IEC 60884-1
Edition 4.0 2022-01

PLUGS AND SOCKET-OUTLETS FOR HOUSEHOLD AND SIMILAR PURPOSES –

Part 1: General requirements

CORRIGENDUM 1

Figure 13 – Arrangement for checking damage to conductors

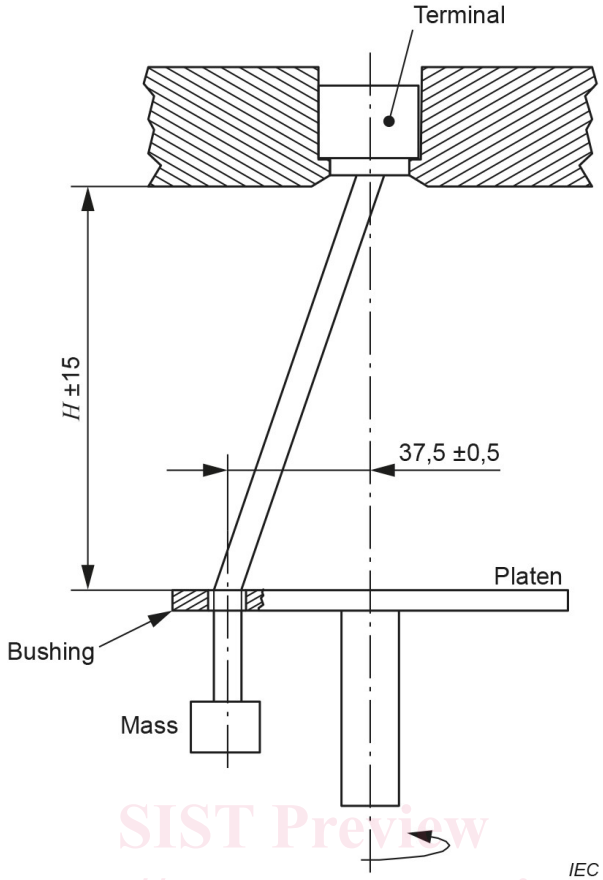
*Replace the dimension "*H ± 1,5*" with "*H ± 15*", as follows:*
